MONTGOMERY COUNTY HISTORIC PRESERVATION COMMISSION
STAFF REPORT

Address:	5918 Cedar Parkway, Chevy Chase	Meeting Date:	5/22/2024
Resource:	Non-Contributing Resource Chevy Chase Village Historic District	Report Date:	5/15/2024
Applicant:	Rebecca & Rob Nichols (Angela Koloszar, Agent)	Public Notice:	5/8/2024
Review:	1067000	Tax Credit:	n/a
Proposal:	Hardscape alterations	Staff:	Dan Bruechert

PROPOSAL

The applicant proposes construct two piers at the driveway entrance to the property.

Figure 2: Proposed site plan showing the piers outside the property boundaries and within the ROW.

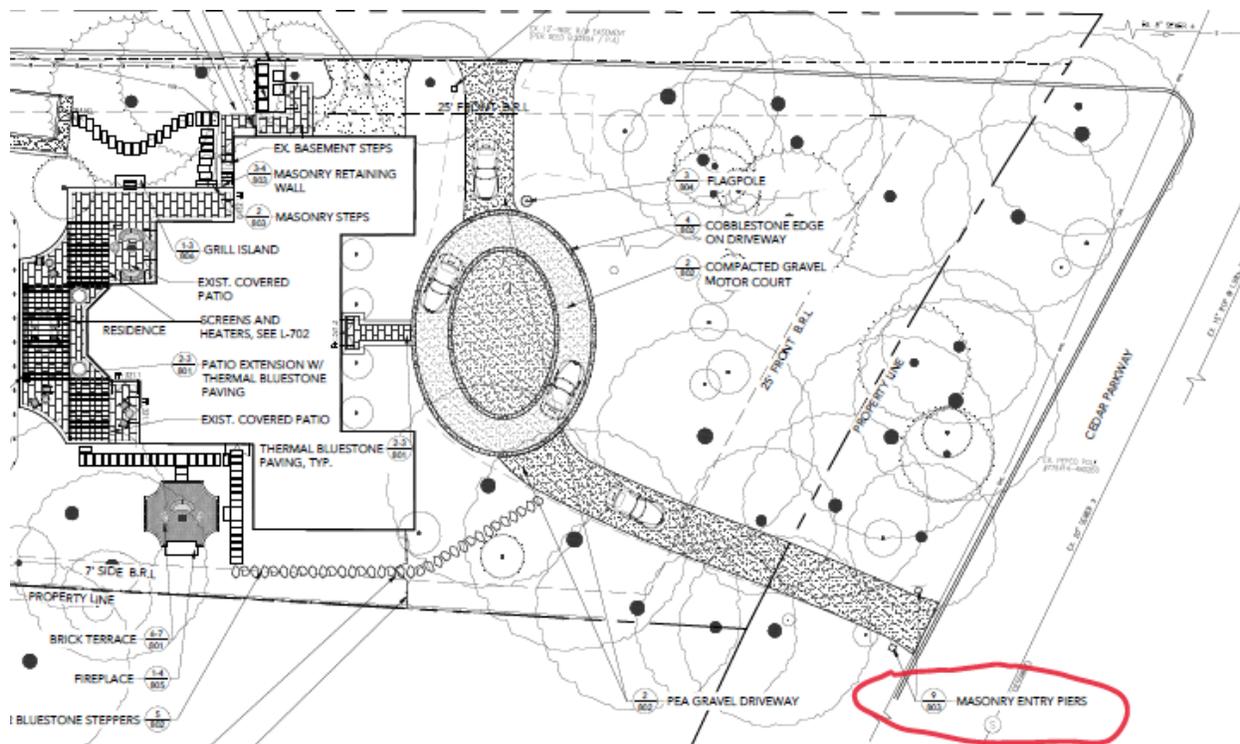
Because the property line is setback so far from the road, the proposed piers are outside the boundaries of the subject property and are located in the right of way. The applicant has discussed this issue with Chevy Chase Village who instructed them to apply for a variance after an approved HAWP.

Staff finds these garden structures should be reviewed under ‘moderate scrutiny’ as they are visible from the public right of way. Staff finds the brick exterior with flagstone caps are consistent with the construction of the house and are materials found throughout the Chevy Chase Historic District. Staff additionally finds the size of these two piers (three feet tall and a foot and a half wide) will not overwhelm the streetscape, nor will their construction impact any of the adjacent trees. Staff finds the size, scale, and materials proposed are all appropriate and recommends the HPC approve the HAWP under the *Design Guidelines*, 24A-8(b)(2) and (d), and Standards 2, 9, and 10.

Staff recommends that the Commission **approve** the HAWP application under the Criteria for Issuance in Chapter 24A-8(b)(2), and (d) having found that the proposal is compatible in character with the district and the purposes of Chapter 24A;
